ADDENDUM # 1

Date: 6/3/2025

IFB #2995
McConnells Collection and Recycling Center Renovations

A1- Drawing S100, NOTES, PLAN & SECTIONS:

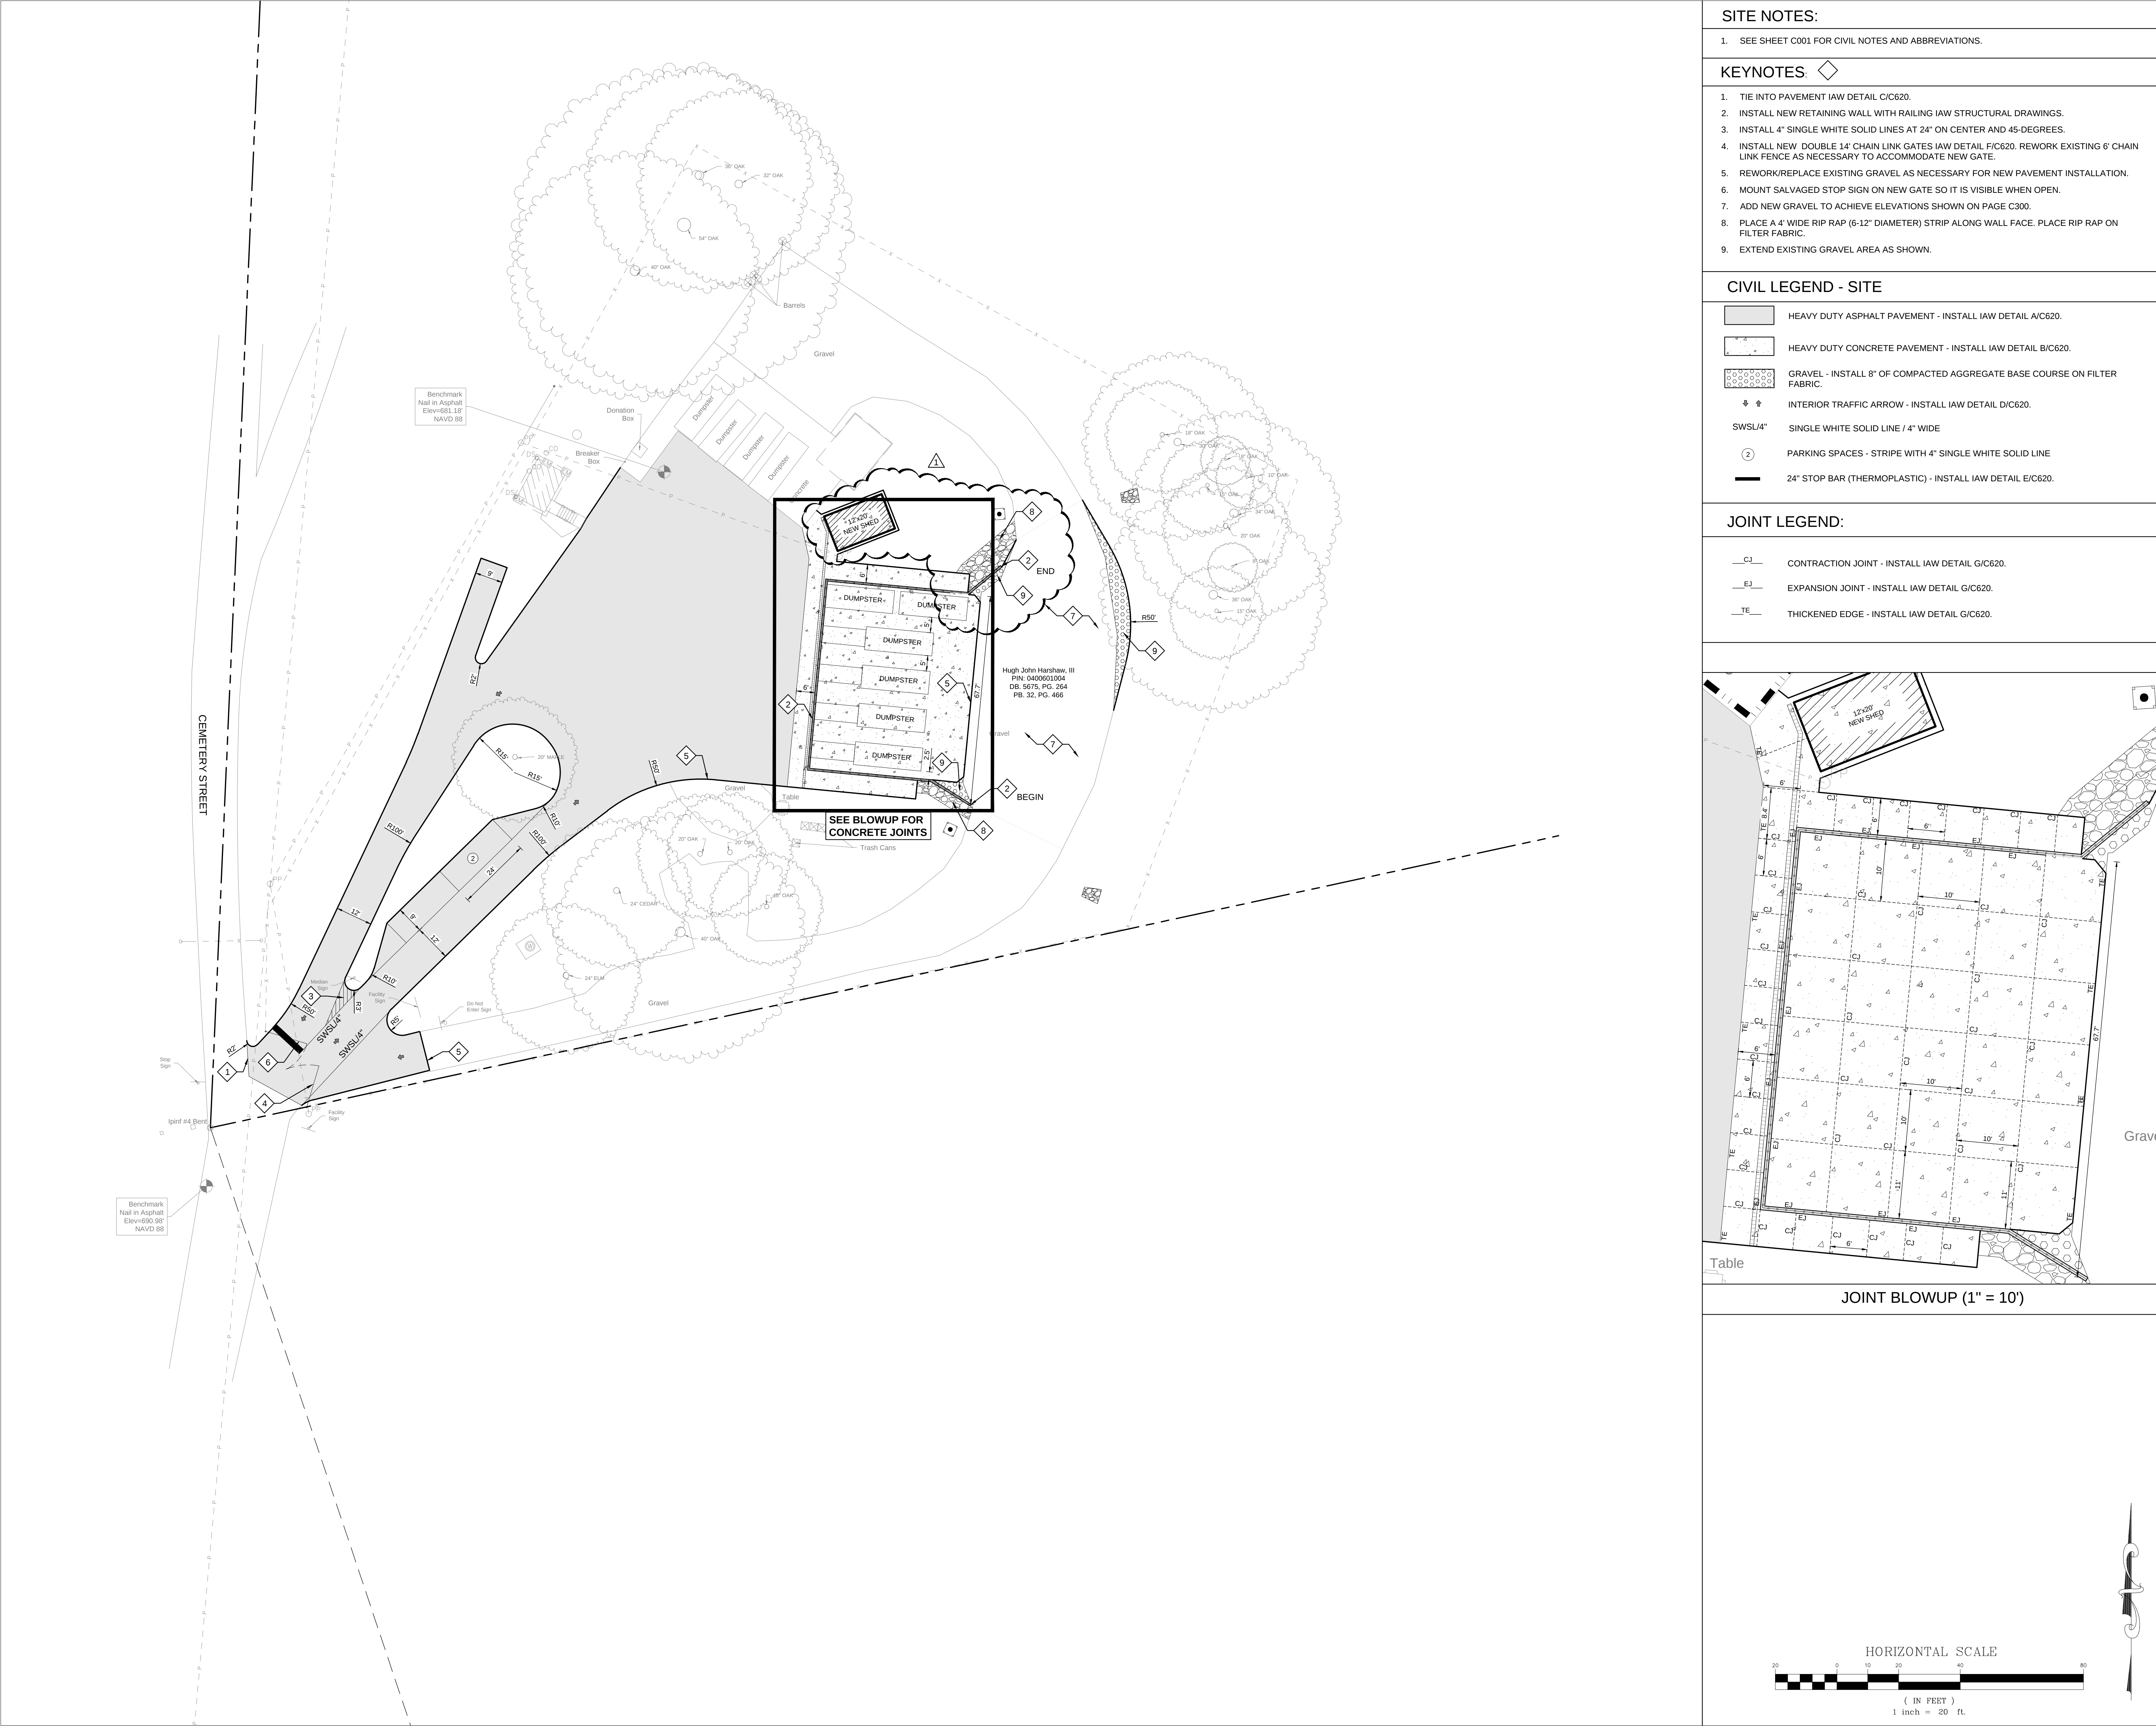
D4 ADD: Add concrete slab for the building that will be provided by the Owner.

ADD: Add Bond Breaker to wall sections.

ADD: Add sidewalk to wall section 2/S100.

Find revised drawing dated, 5.30.2025 attached.

C200

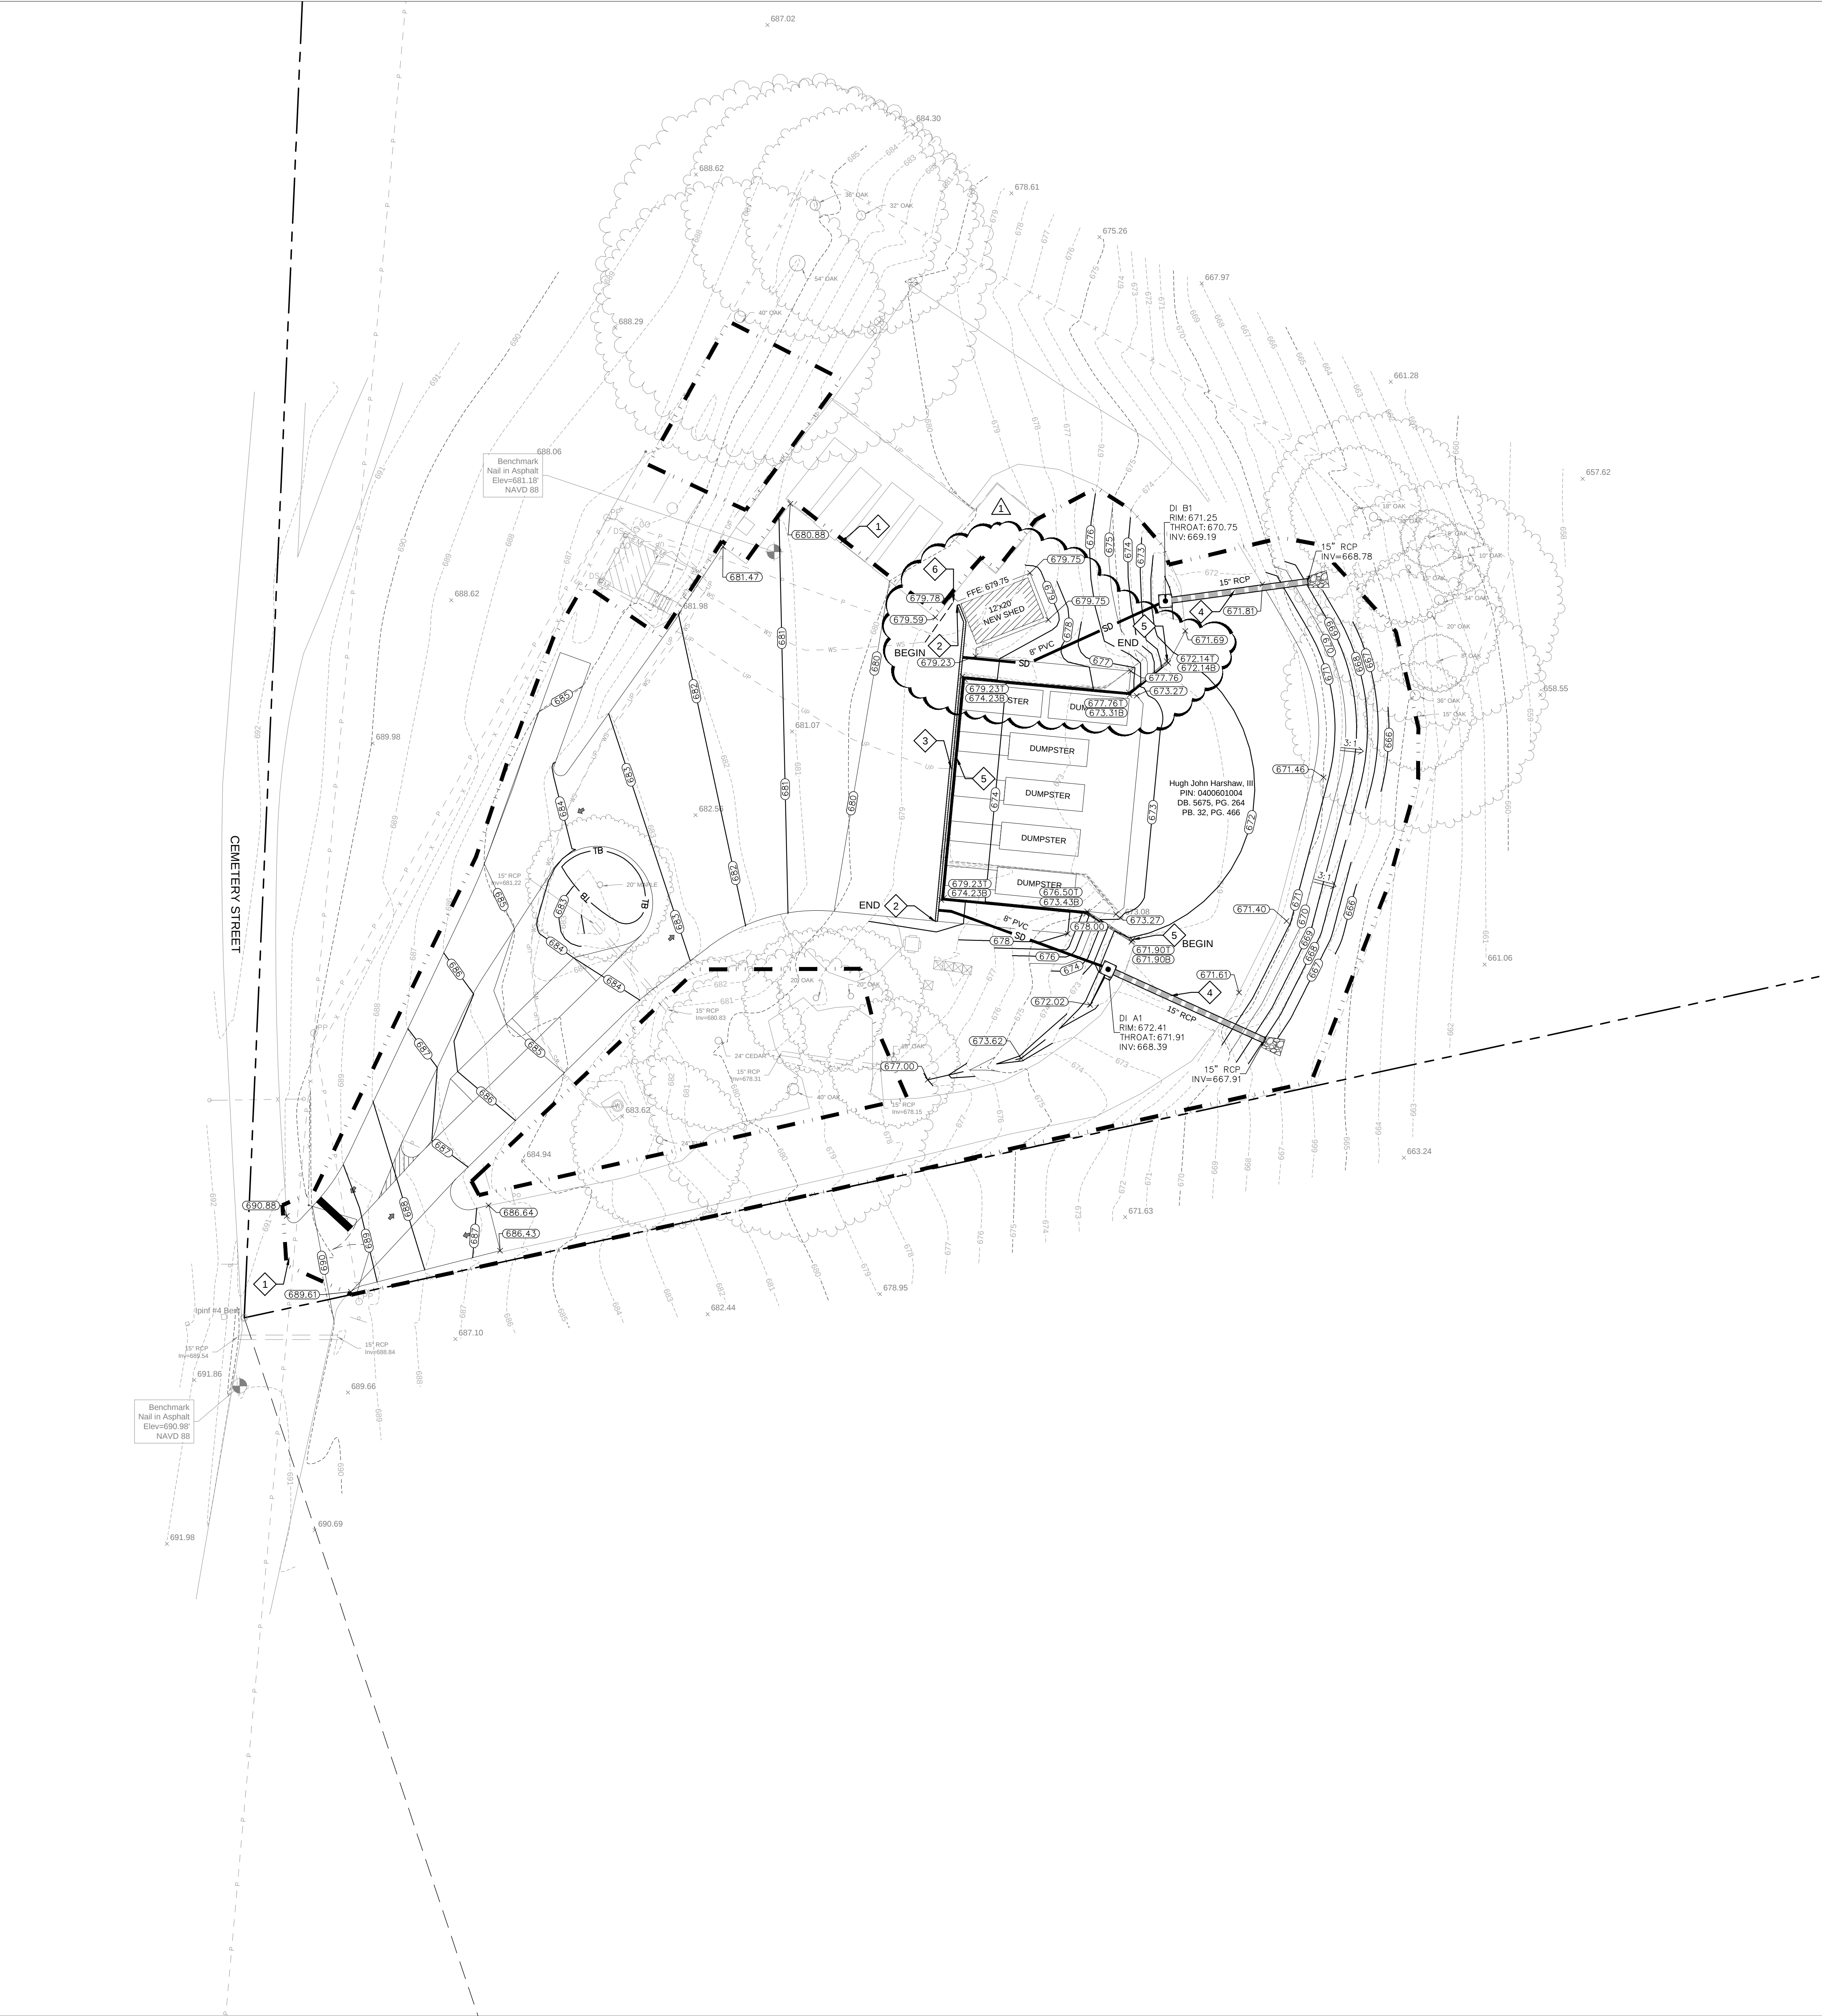
A1- Drawing C200, SITE PLAN:

D1 ADD: Add concrete pad for the new shed that will be purchased by the Owner.

ADD: Extend the north sidewalk to extend to the end of the dumpster.
Find revised drawing dated 5/30/25 attached.

C300

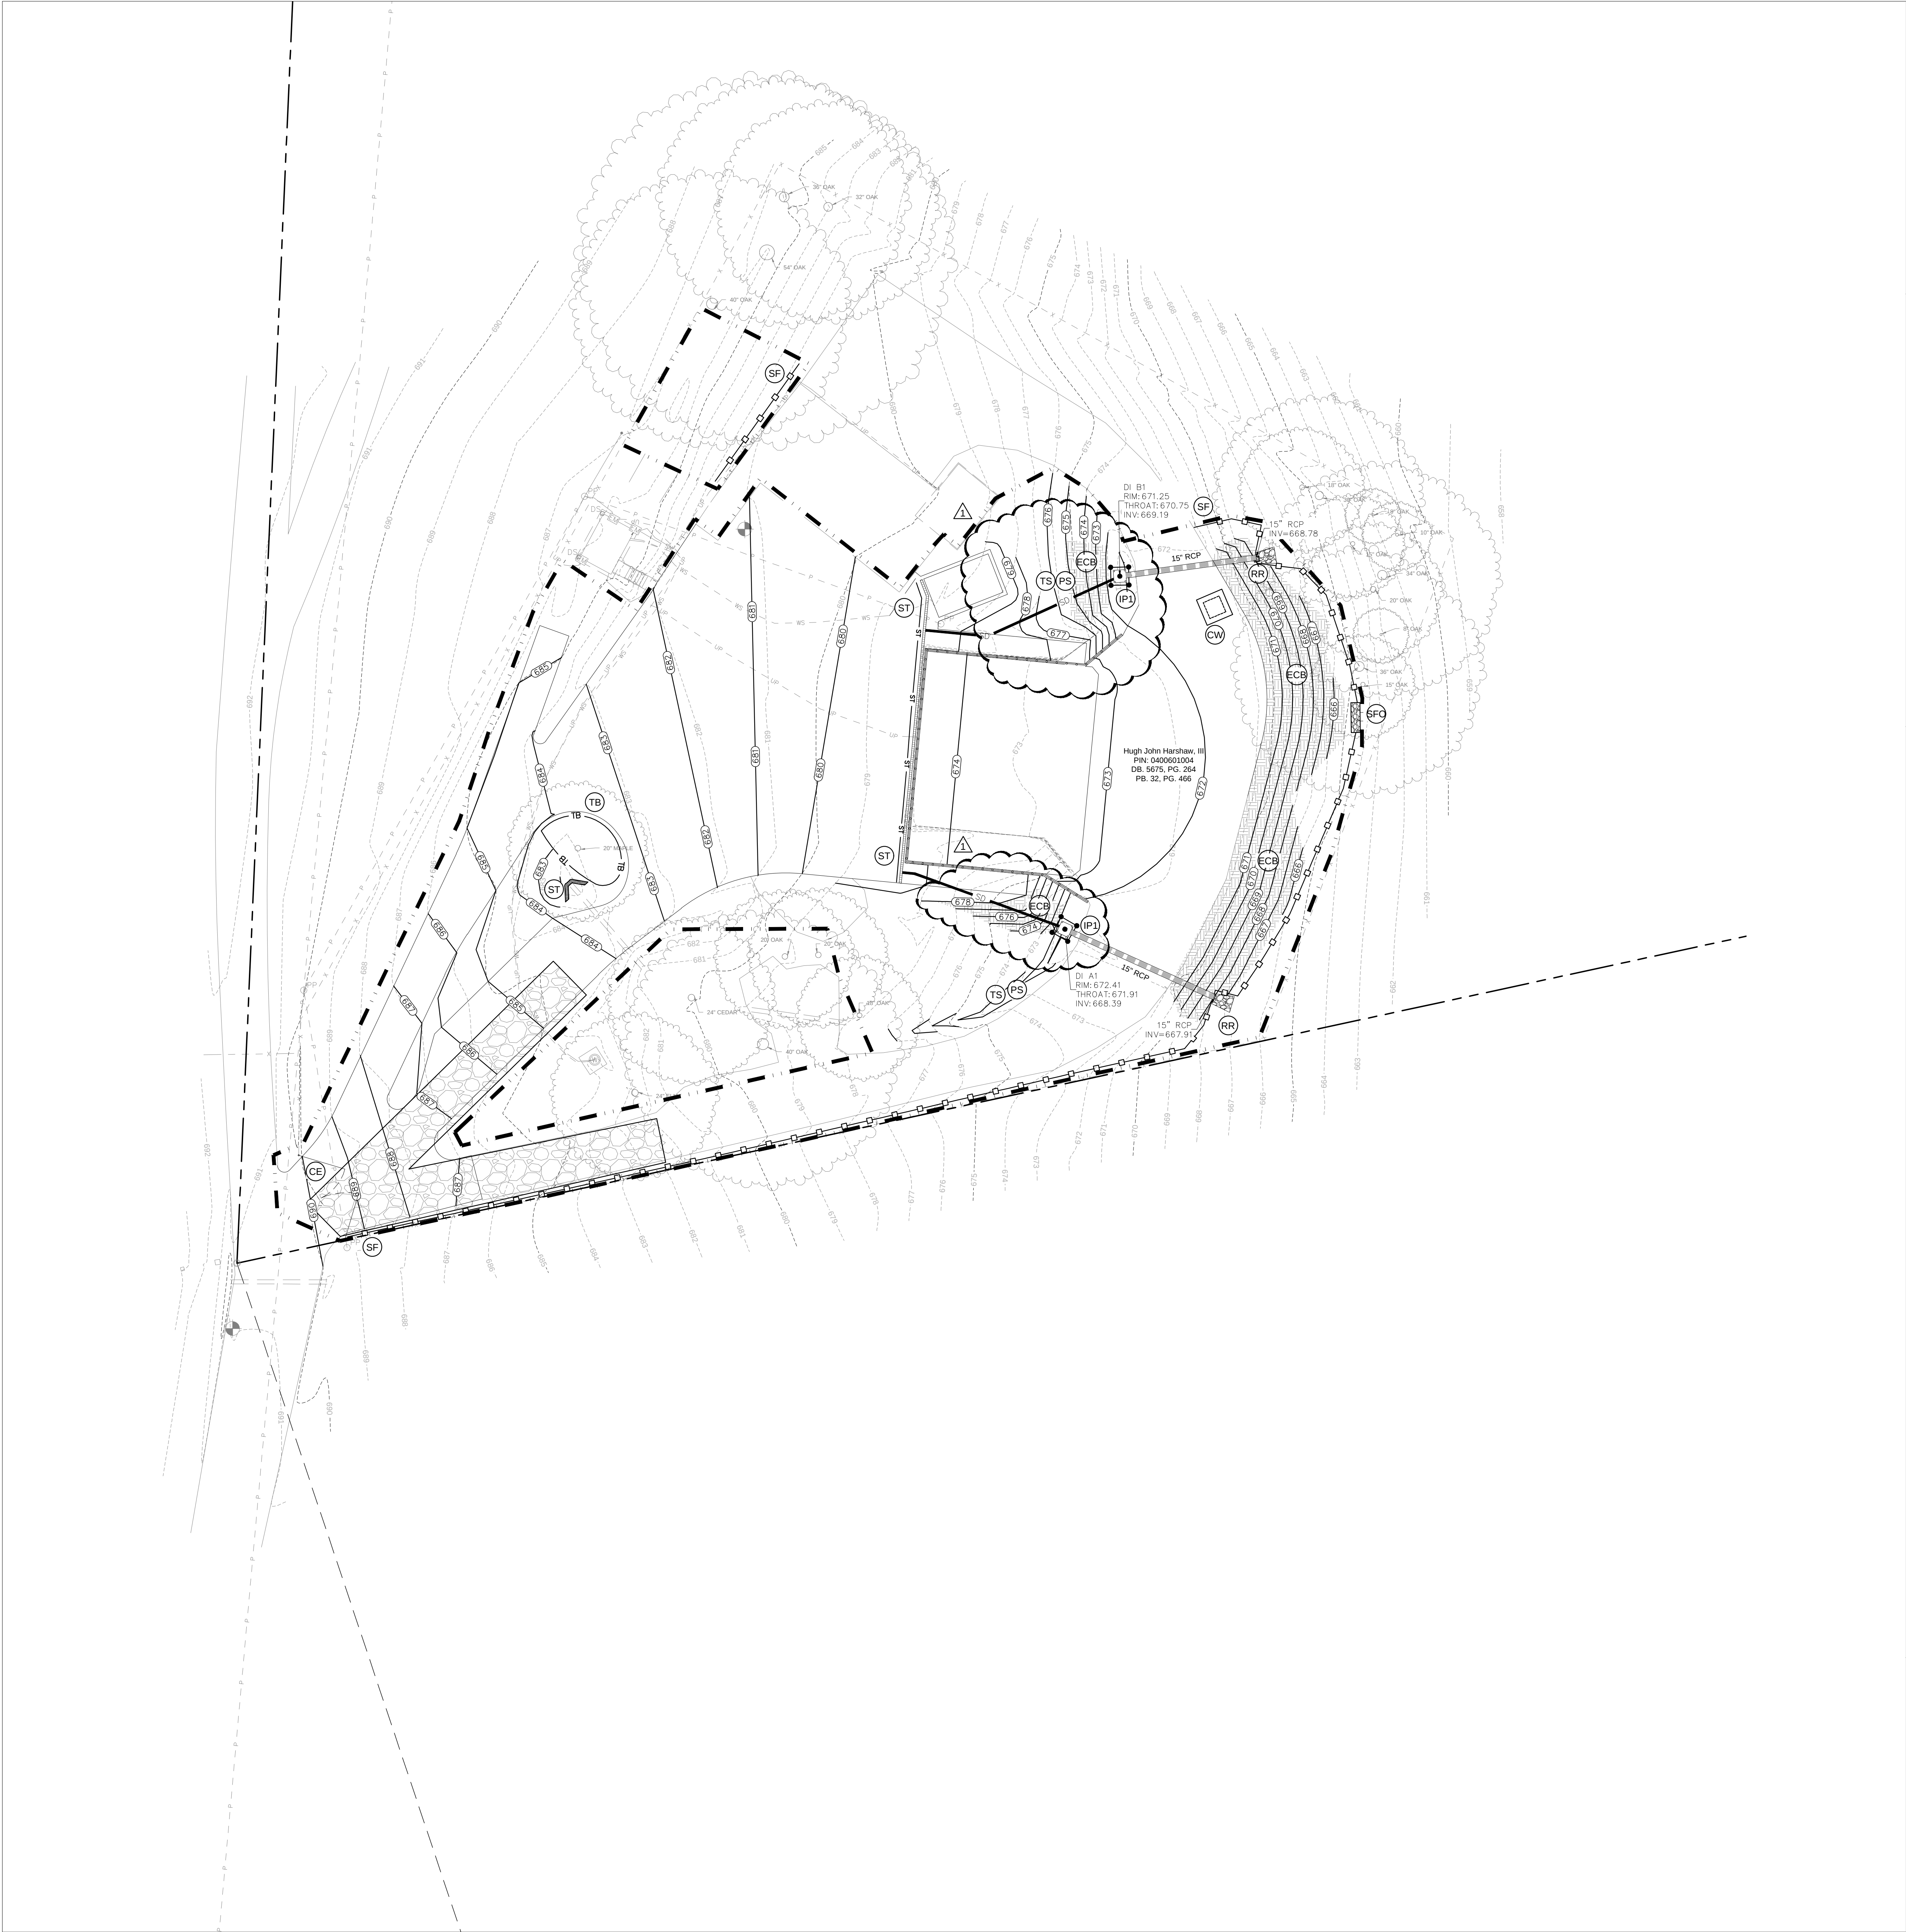
A1- Drawing C300, GRADING PLAN:

D2 REVISE: Grades along north wall to extend the sidewalk. Find revised drawing dated 5/30/25 attached.
